ADDENDUM NO. 01

Project No.24076

Project Name: TFSD Lincoln HVAC Replacement
Address: Twin Falls, Idaho

Date Issued: March 27, 2025

Sheet No:
M2.02

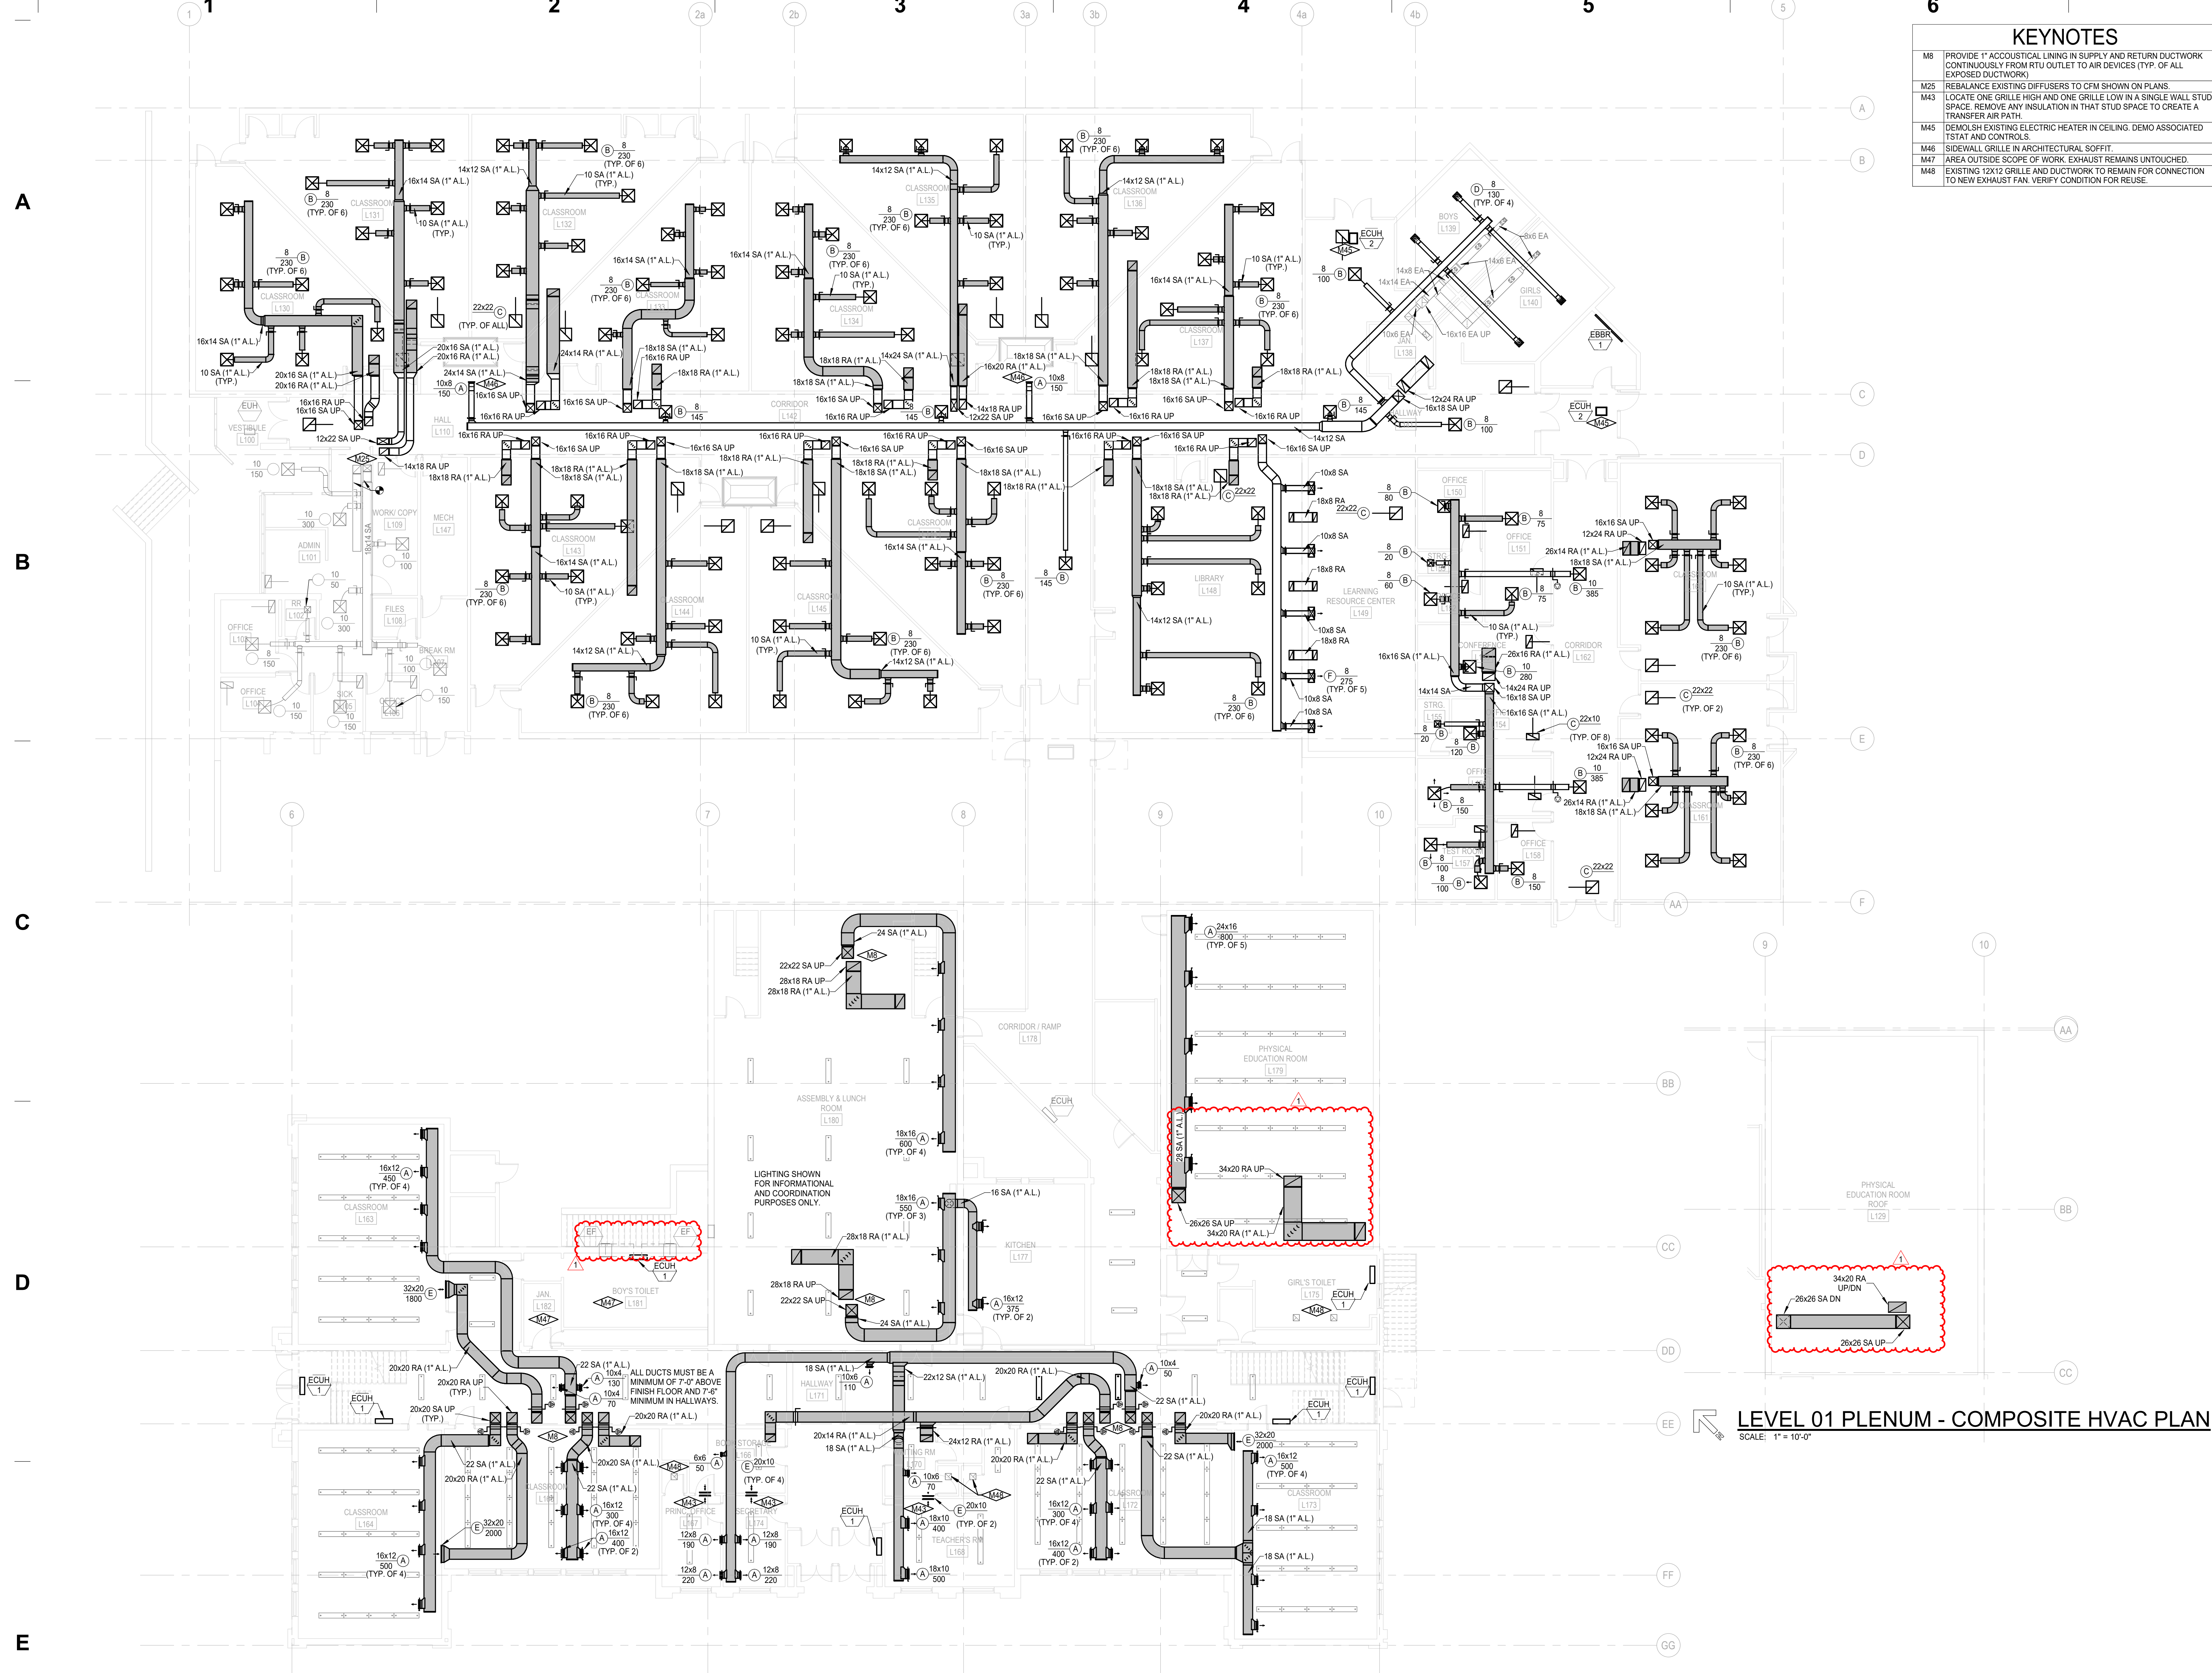
M2.02 – LEVEL 01 – HVAC PLAN

1. REVISED PLANS TO SHOW 2 EXISTING EXHAUST FANS IN BOY'S TOILET TO REMAIN
2. REVISED DUCTWORK IN PHYSICAL EDUCATION ROOM TO AVOID UPDATED LIGHTING LOCATIONS
3. REVISED DUCTWORK IN PHYSICAL EDUCATION PLENUM TO AVOID UPDATED LIGHTING IN ROOM BELOW

Sheet No:
M2.03

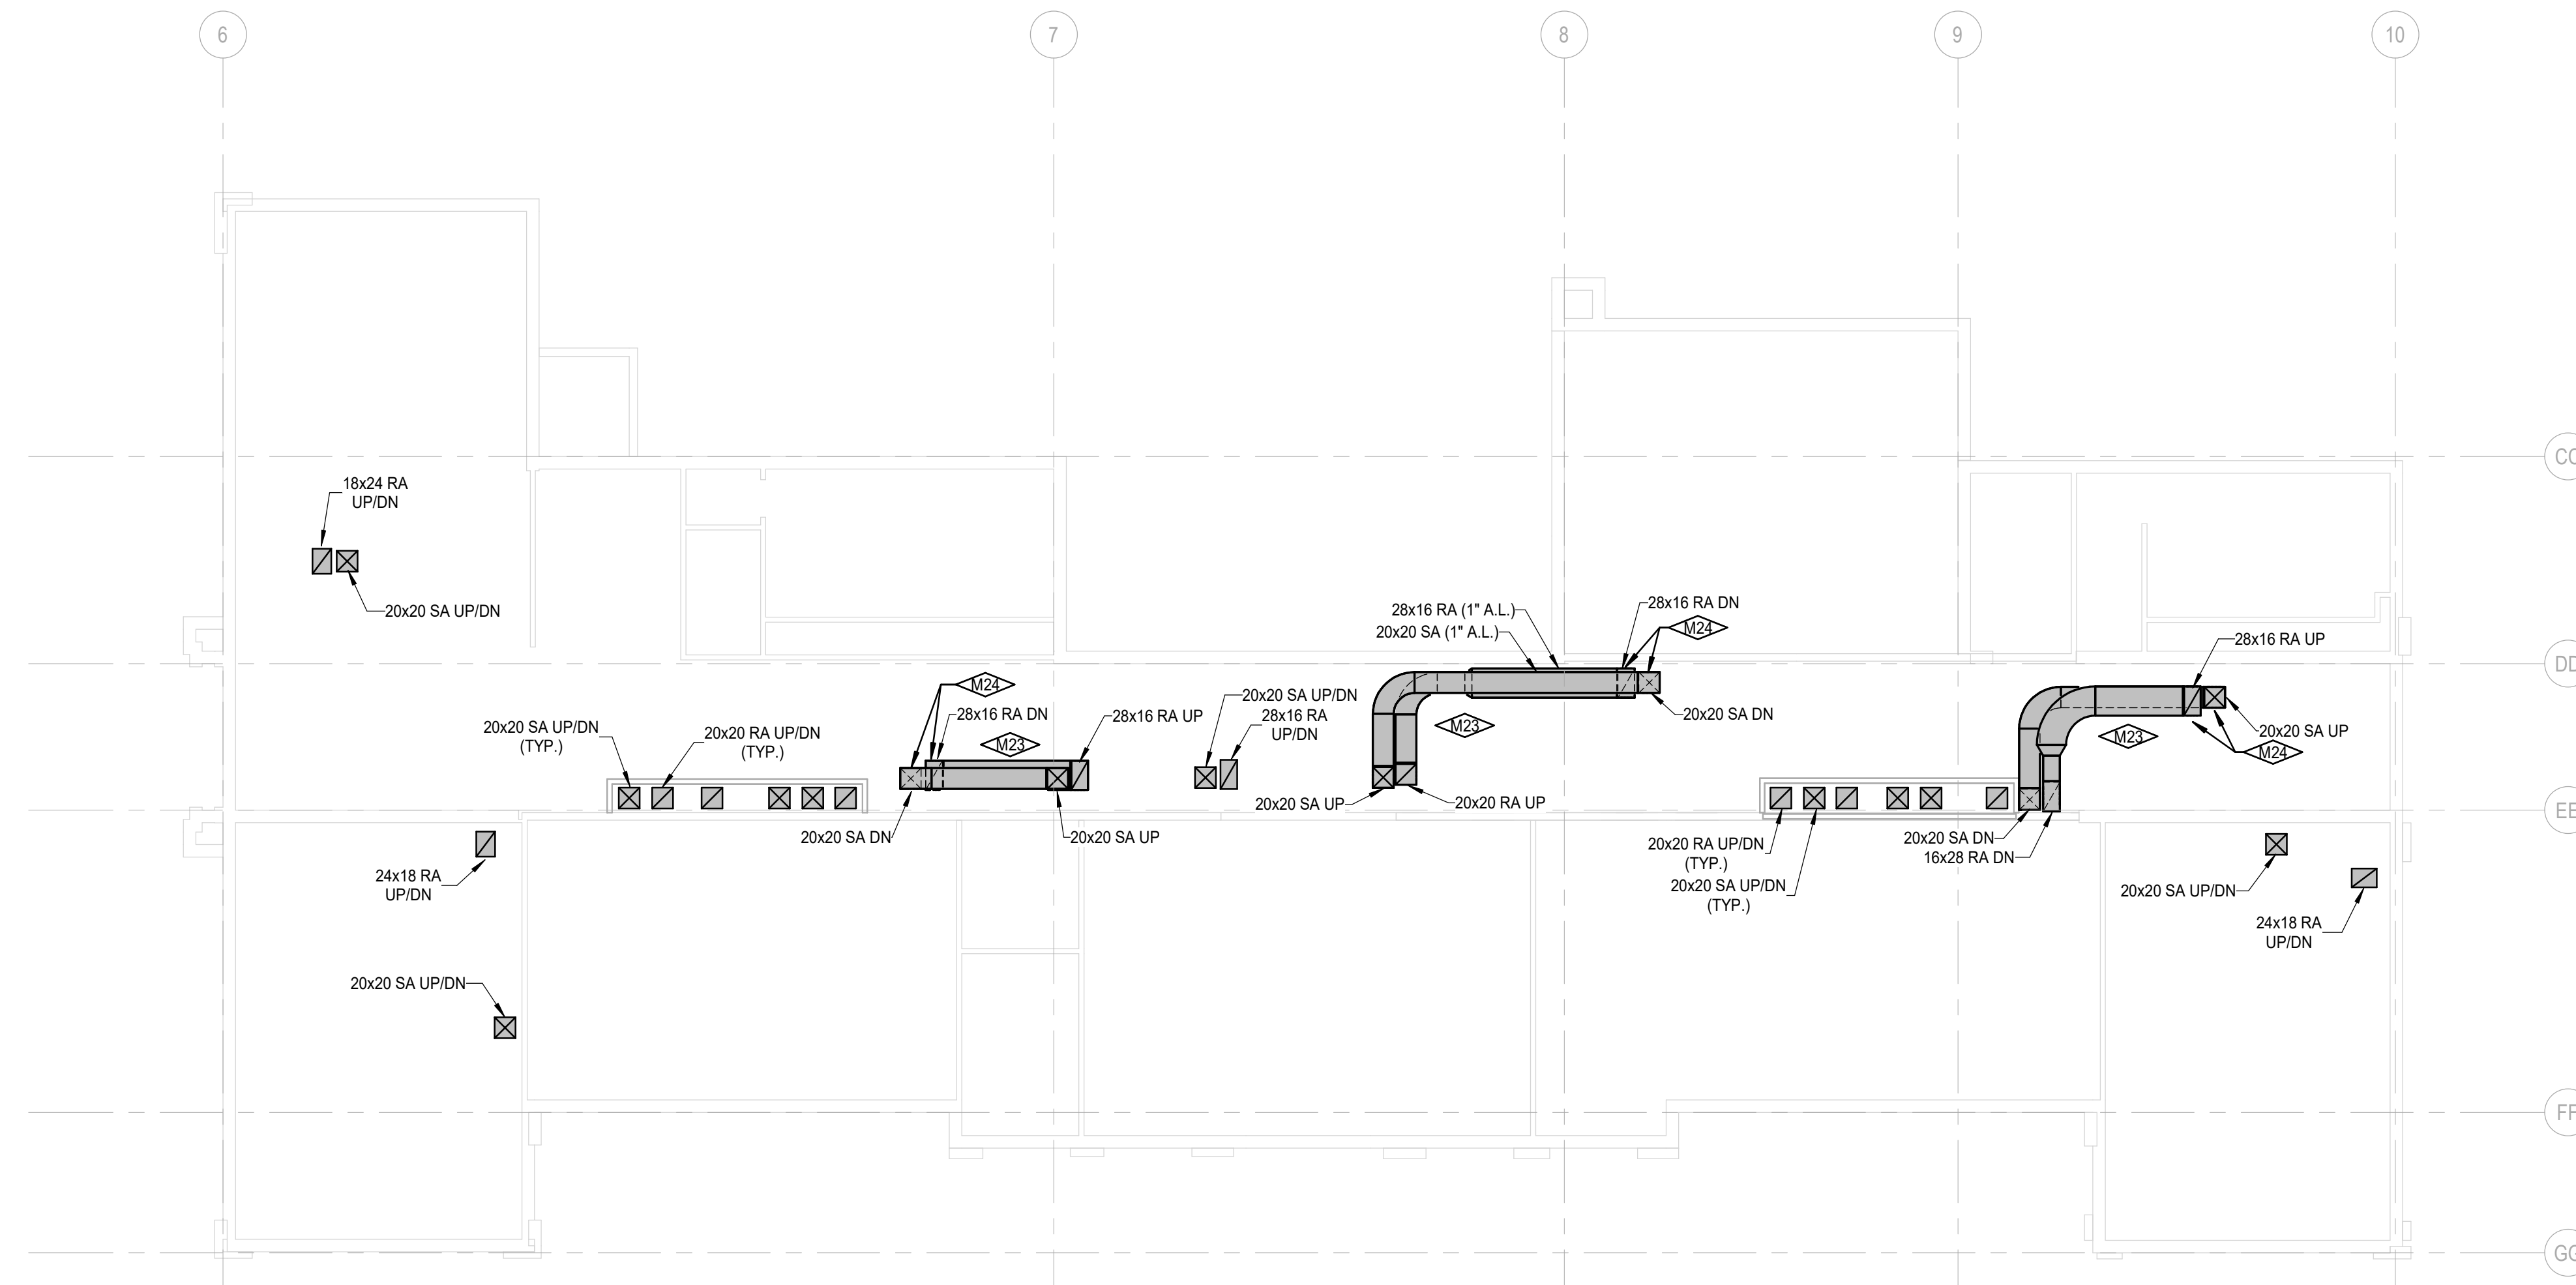
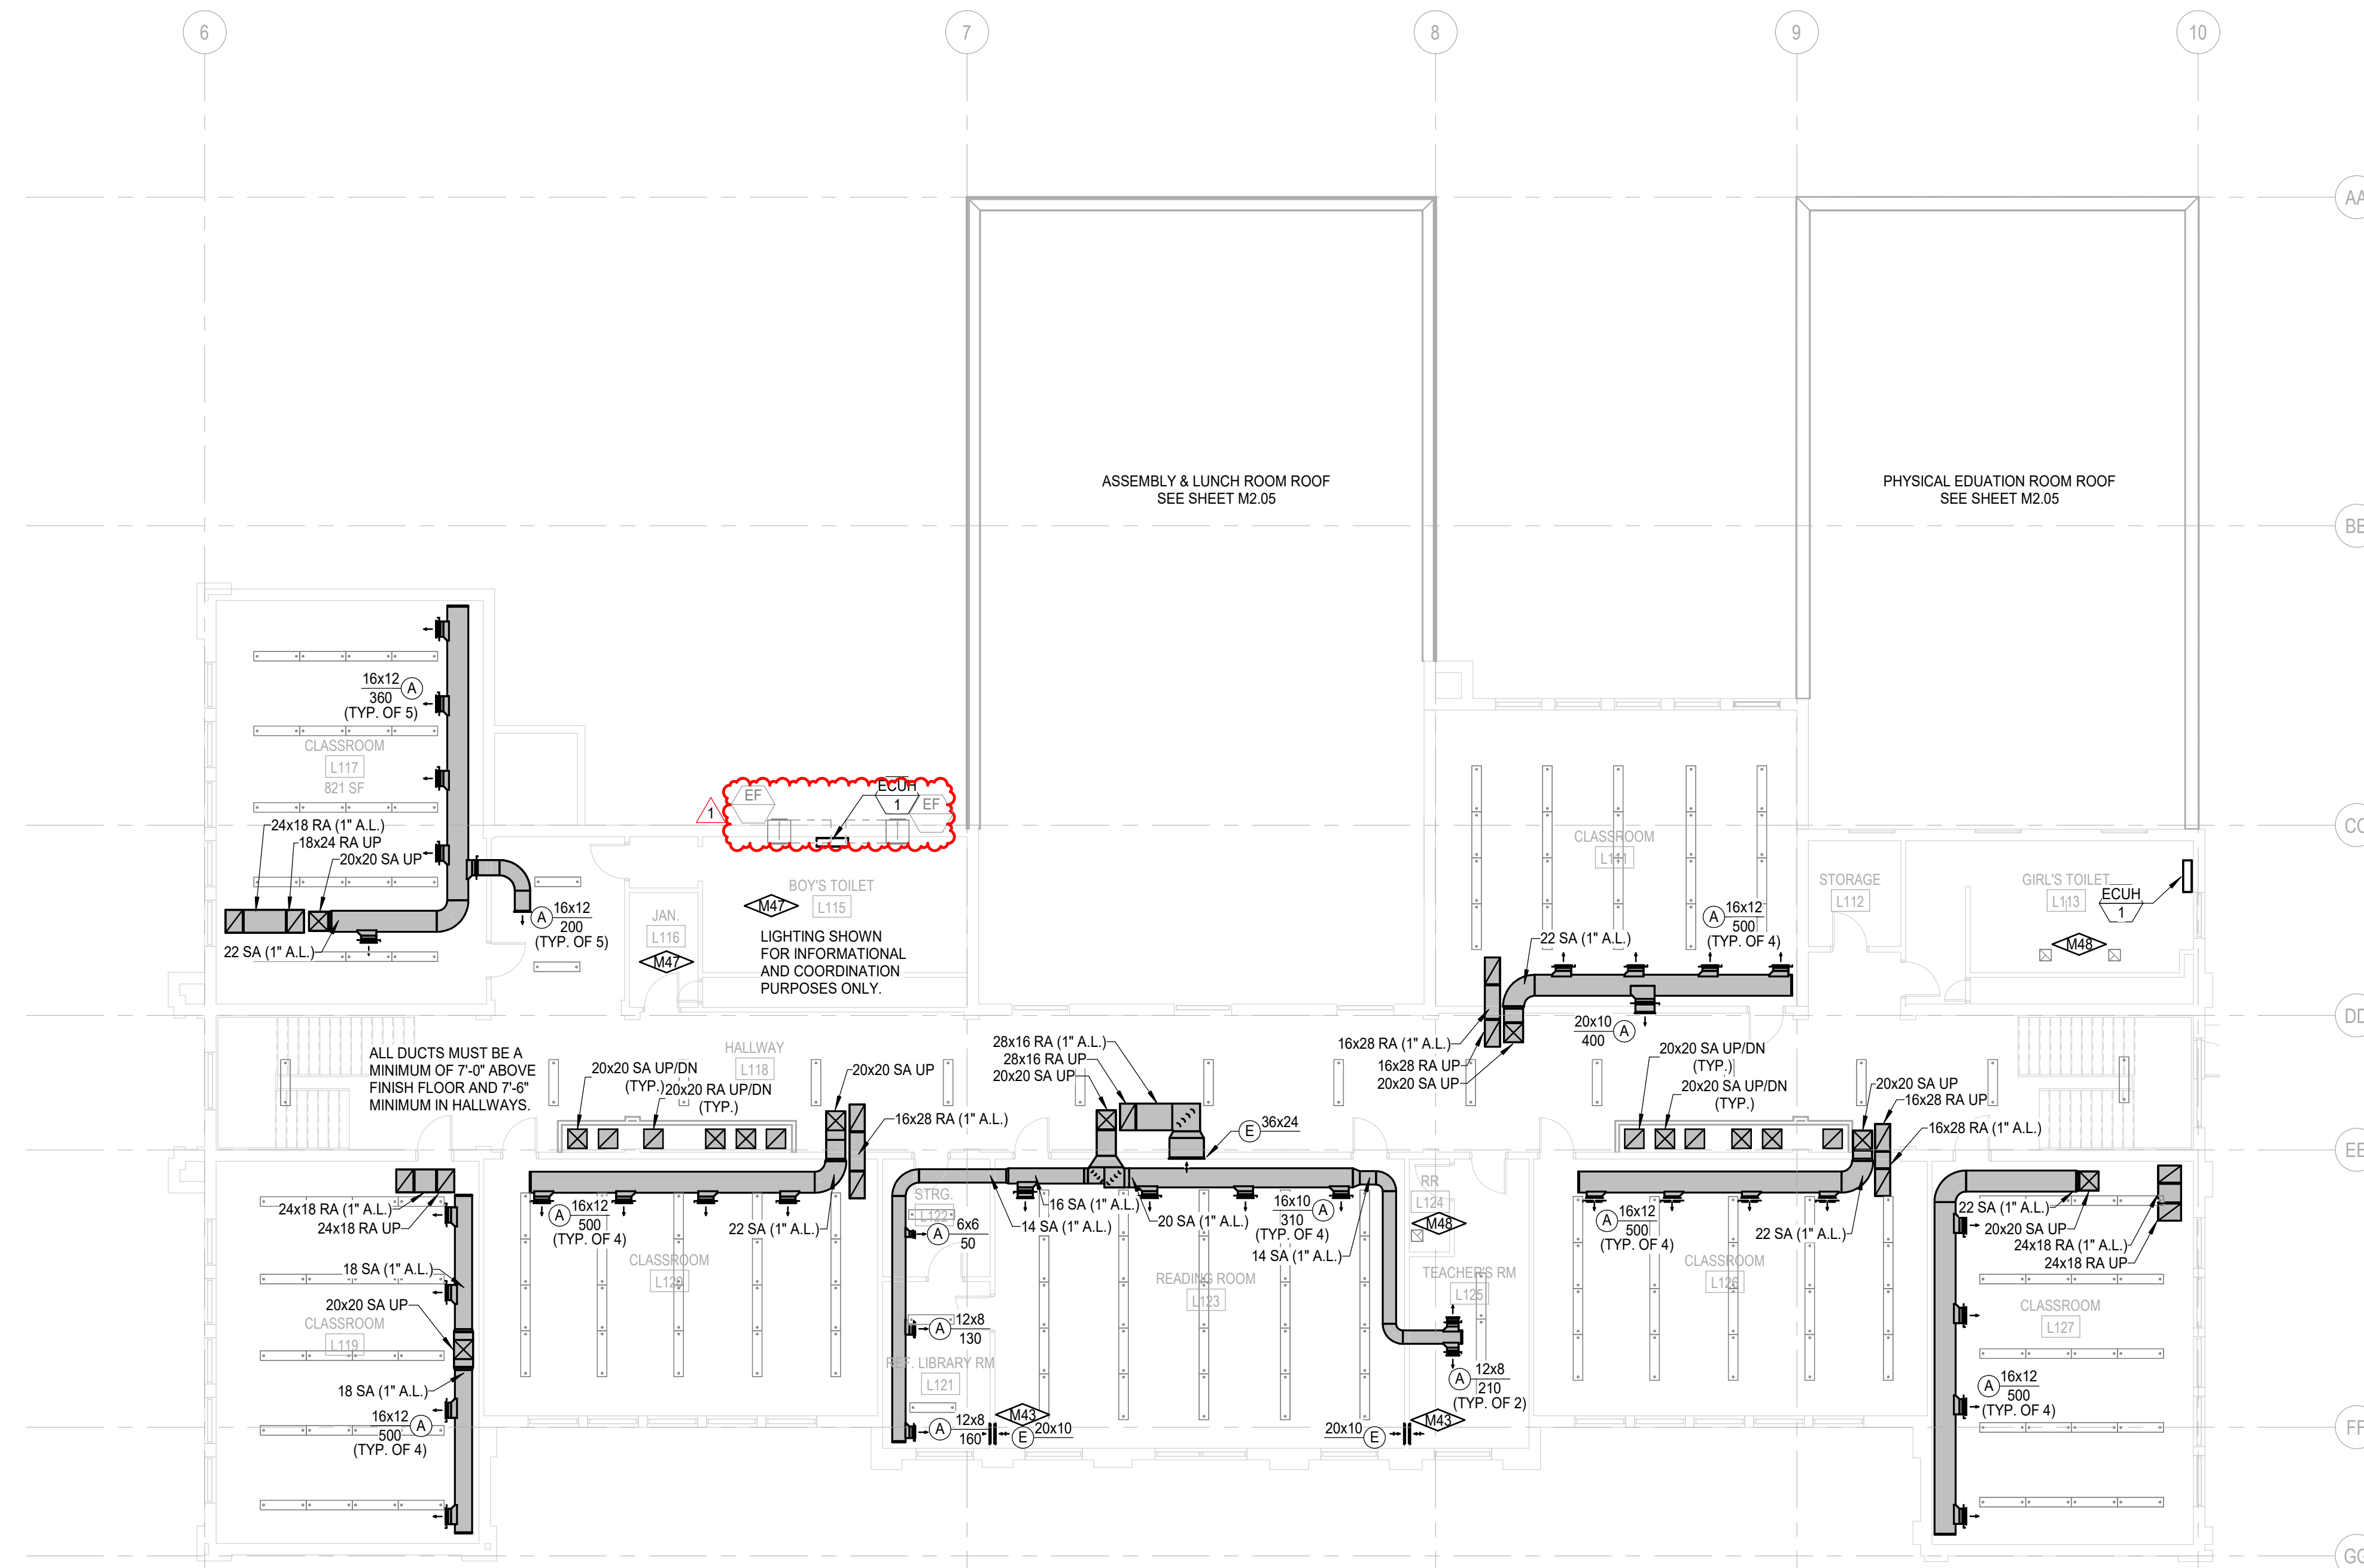
M2.03 – LEVEL 02 – HVAC PLAN

1. REVISED PLANS TO SHOW 2 EXISTING EXHAUST FANS IN BOY'S TOILET TO REMAIN
